PROJECT ADDRESS: 3621 S. HARBOR BLVD.	SUITE: 150	SAPIN # 10174235
USE OF BUILDING: RESIDENTIAL <u>COMMERCIAL</u> INDUSTRIAL OTHER	2012-101249 MASTER ID#	
NATURE OF WORK: NEW ADD <u>ALTER/I.</u> DEMO REROOF REPAIR SIGN MISC	VALUATION: \$ 27,455.00

JOB DESCRIPTION (non-residential projects see reverse side of this application): REPLACE EXISTING SINGLE ENTRY DOOR W/NEW DOUBLE RATED DOOR - PROVIDE INSULATION IN EXISTING DEMISING WALL; DEMO 3 INTERIOR WALLS, 2 DOORS AND ONE WINDOW; SOUNDPROOFING IN OPEN OFFICES; NEW FINISHES.

TENANT IMPROVEMENT PLAN CHECK COMMENTS

PLAN CHECK NO:	10174235		
PROJECT ADDRESS:	3621 S Harbor Blvd Unit# 150		
PLAN CHECK ENGINEER:	Ahangian, Kathy	TEL: 714	647-5812
		FAX: 714	647-5897
TYPE OF CONSTRUCTION:	V B, SPK		
OCCUPANCY CLASSIFICATION(S):	B		
PLAN CHECK DATES:		REMARKS/RECHECK ITEMS:	
APPLICATION	1/26/2012		
INITIAL REVIEW	2/5/2012		
EXPIRATION	7/24/2012		
RECHECKS:	1.	PROJECT APPLICANT CONTACT PERSON:	
	2.	Randall Patrick	
	3.	TEL:	(949)724-1499
		FAX:	(949)724-1877
VALUATION:	\$43,870.00	EMAIL:	rand@spaces-oc.com
FLOOD ZONE:	X-0602320258J

FIRST FLOOR
 PARTITION PLAN

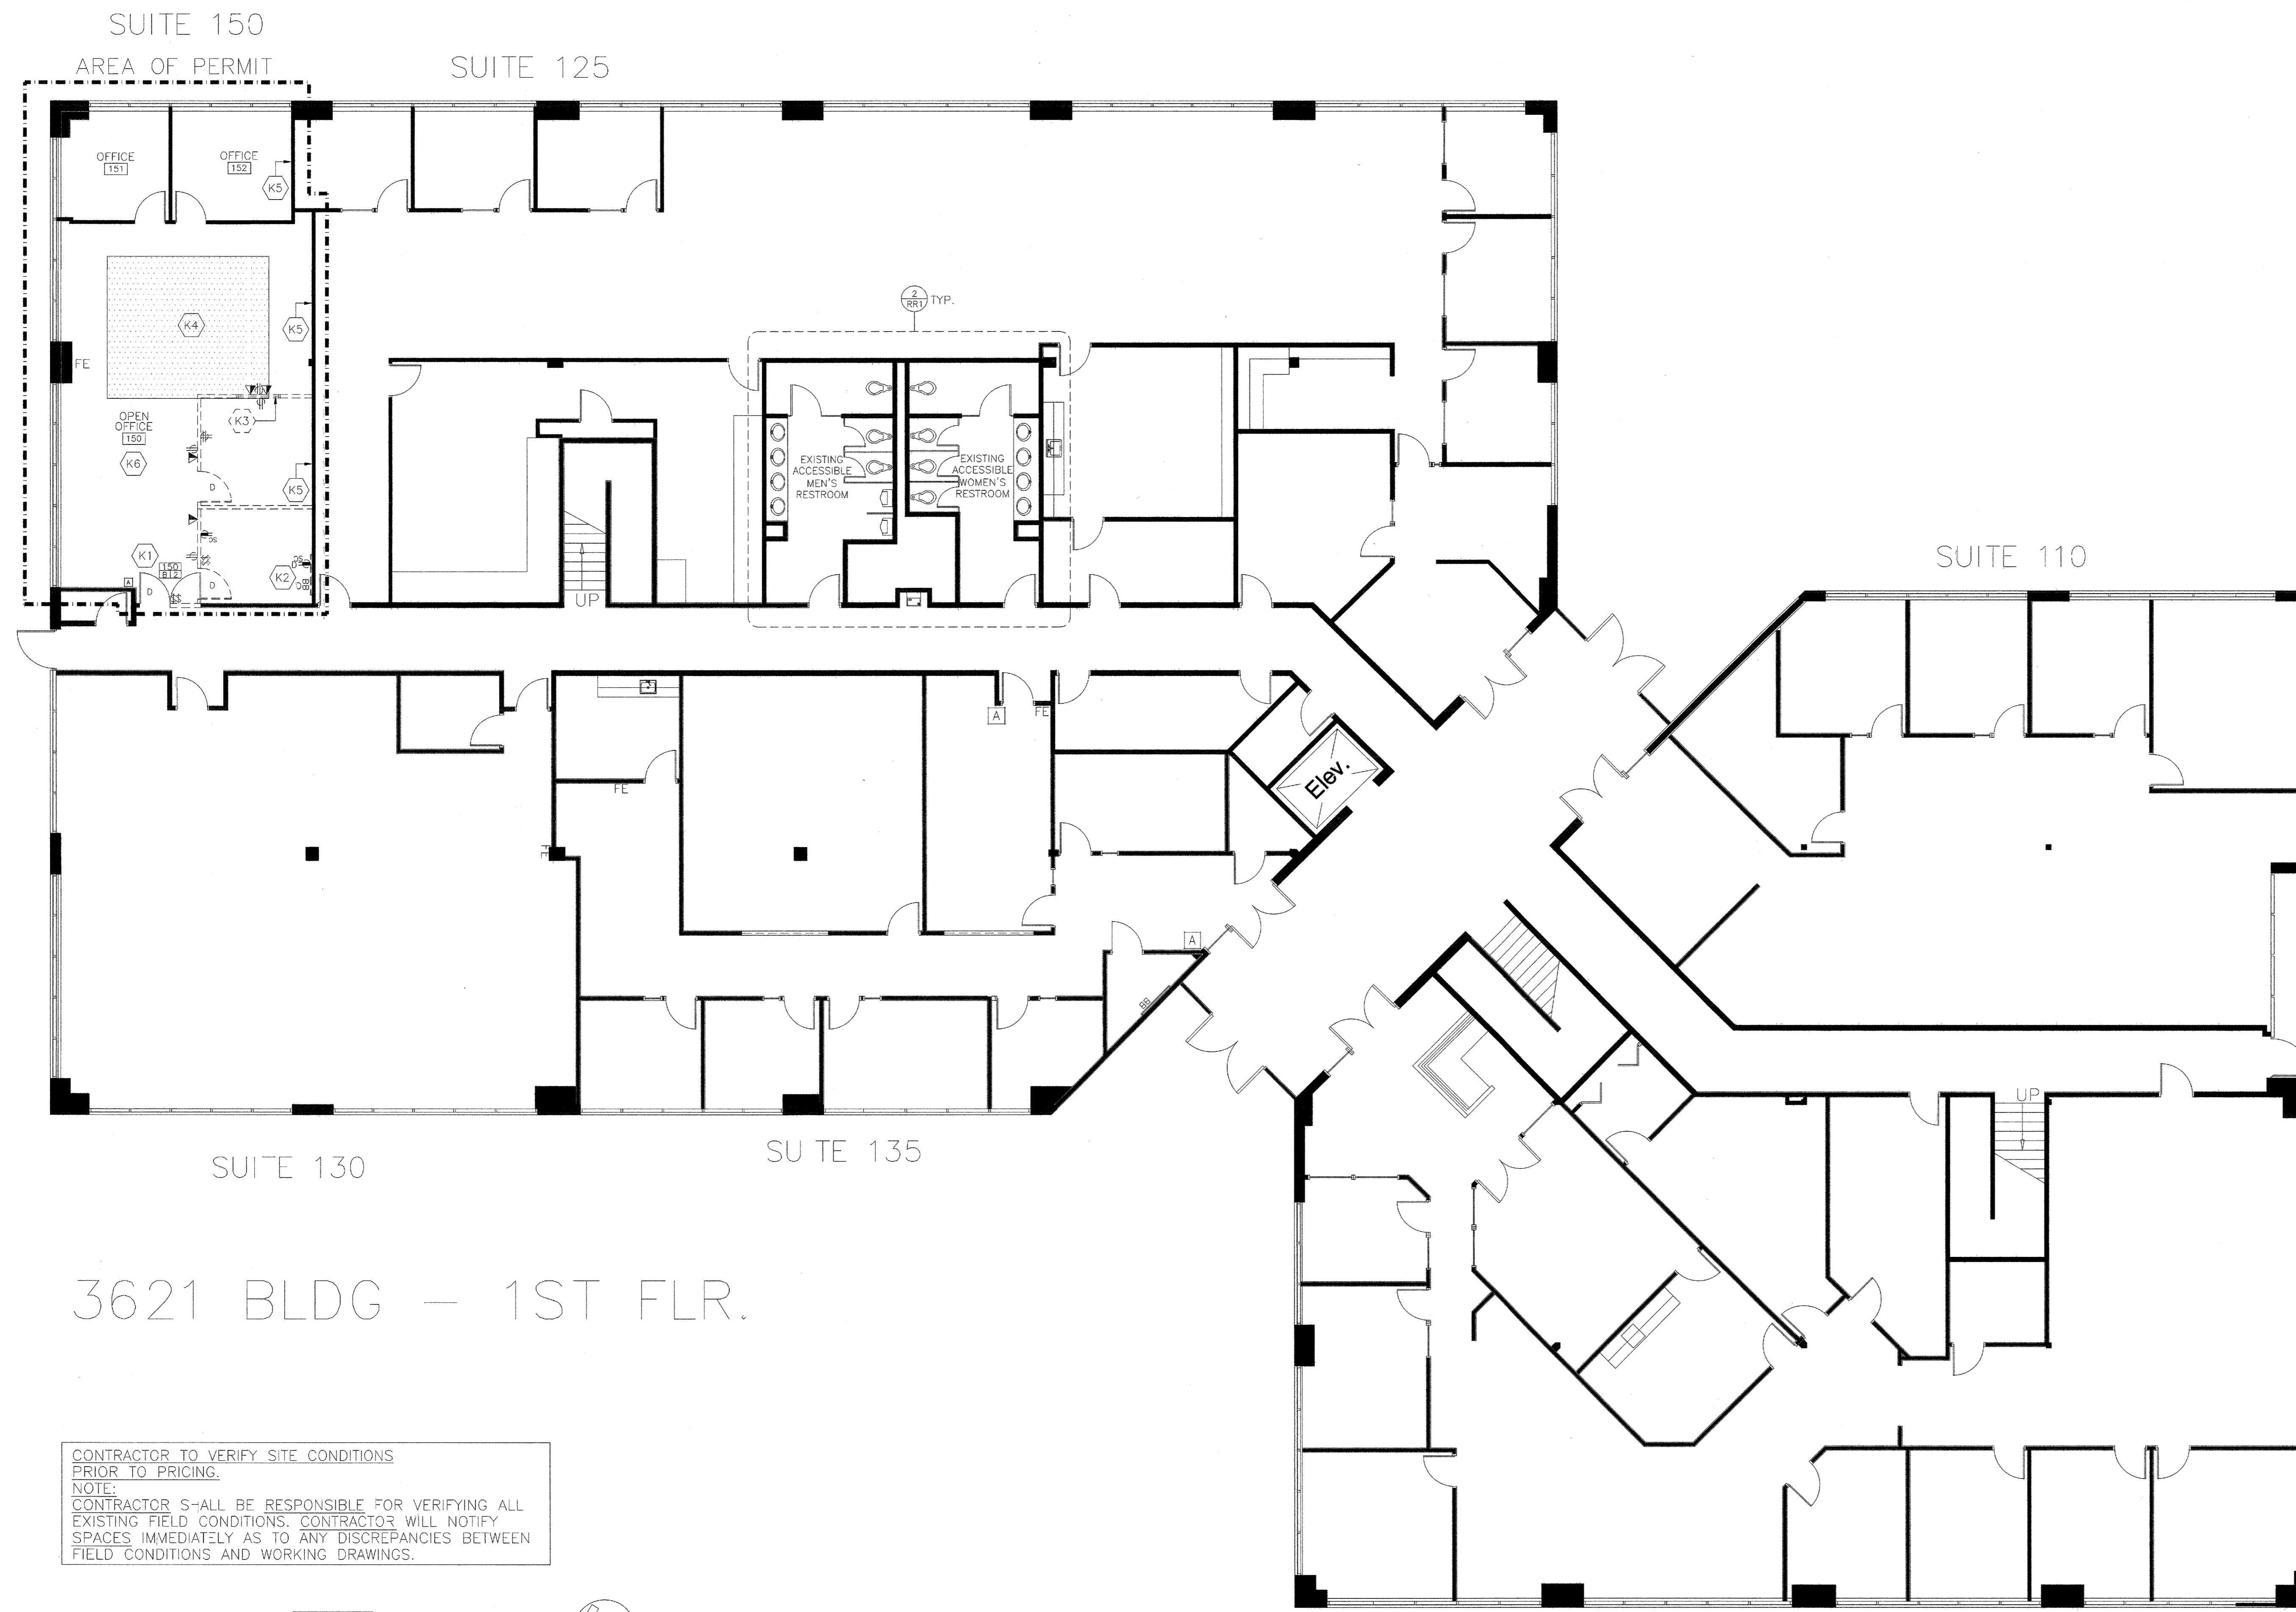
✓ 10. Show how required fire resistive integrity will be maintained for the corridor where the new door will be installed. AND NEW BRACING DETAIL (#3/A5)
SEE REVISED KEYNOTE K1 & GEN. NOTE #8 ON A-1, AND DOOR HARDWARE # 2 & DOOR ELEVATION "B" ON A-4.

- (K5) PONY-UP EXISTING INTERIOR DEMISING WALL TO BECOME FULL-HEIGHT SOUND-INSULATED BUILDING STANDARD DEMISING WALL-IF NOT ALREADY. SEE DETAIL #2 ON SHEET A-5 FOR TYPICAL BUILDING STANDARD DEMISING WALL CONSTRUCTION. INSULATION TO EXTEND TO DECK ABOVE. IF EXISTING WALL IS NOT FULL HEIGHT, EXTEND WALL TO DECK ABOVE, AND PROVIDE BRACING AS REQUIRED FOR STRUCTURAL STABILITY. SEE BRACING DETAIL #3 ON A-5.

2 FULL HEIGHT DEMISING WALL
FH DEM WALL
SCALE: 1/2" = 1'-0"

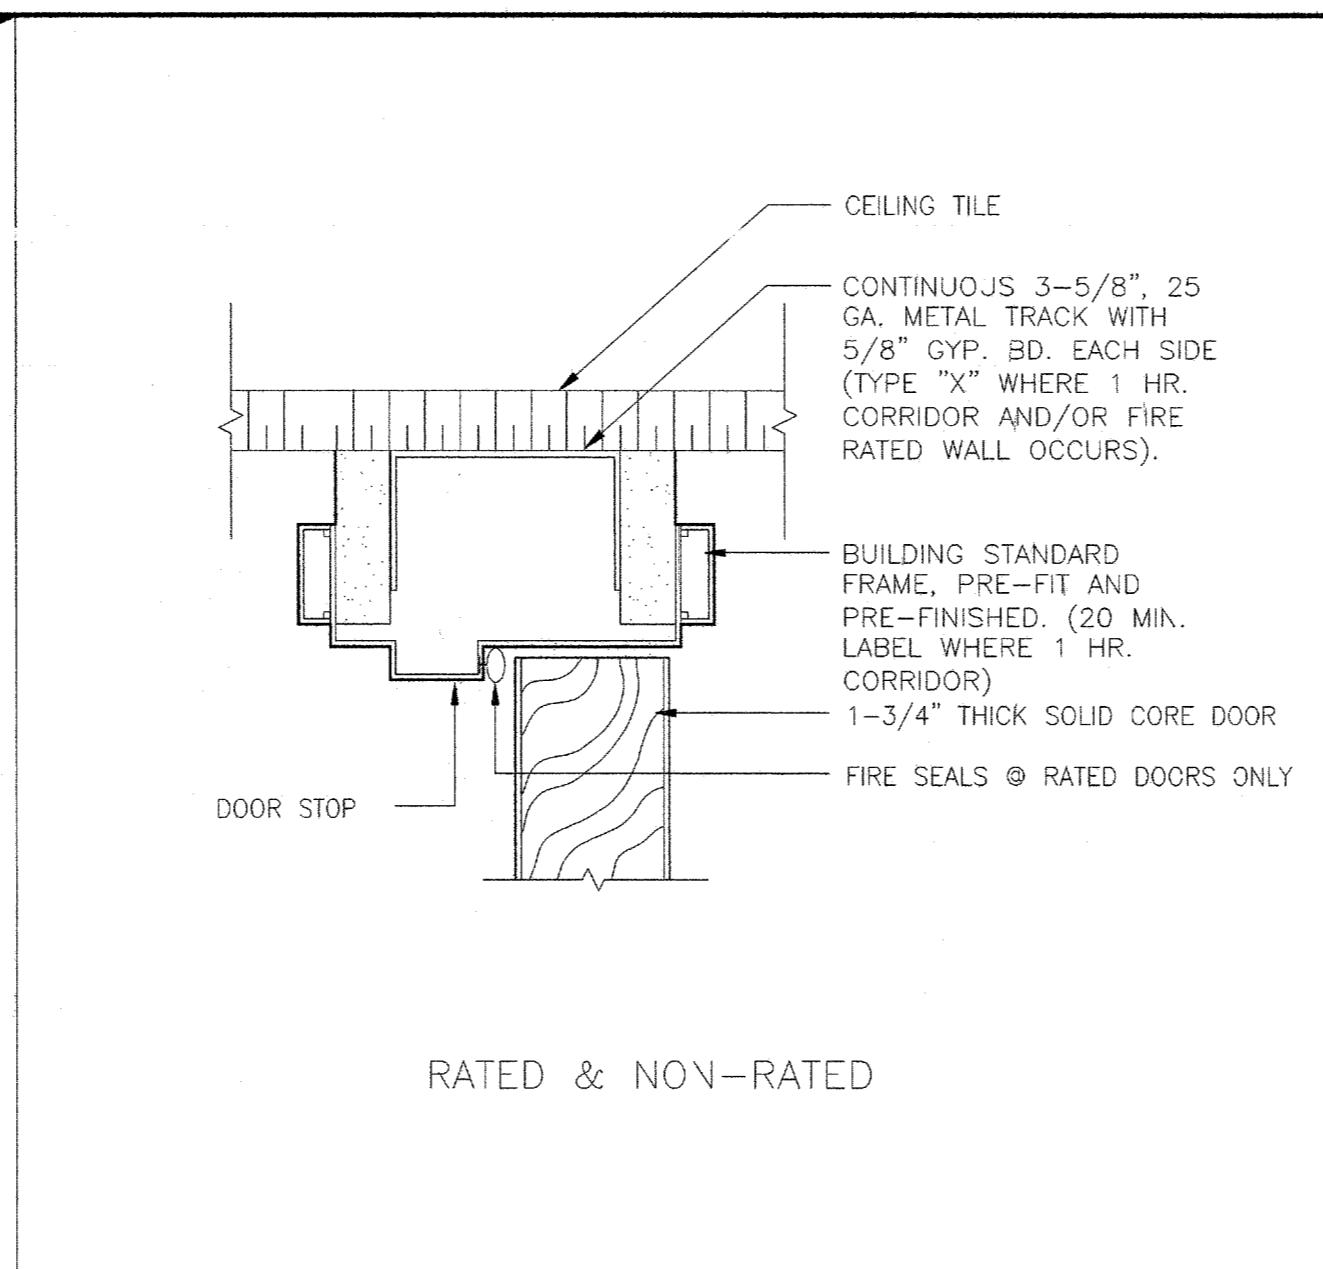
2-21-12
OK
8. Clarify if existing K5 note (pony up) is low wall or full height wall, and change detail 2/A-5 accordingly. (In both situation the detail needs to be changed.)

KA
9. Show exit signs in the corridor. EXISTING DEMISING WALL IS PROBABLY BUILDING STANDARD FULL HEIGHT WALL. G.C. TO VERIFY & PONY UP TO THE DECK IF NEC/SEE REVISED KEYNOTE K5 ON A-1;
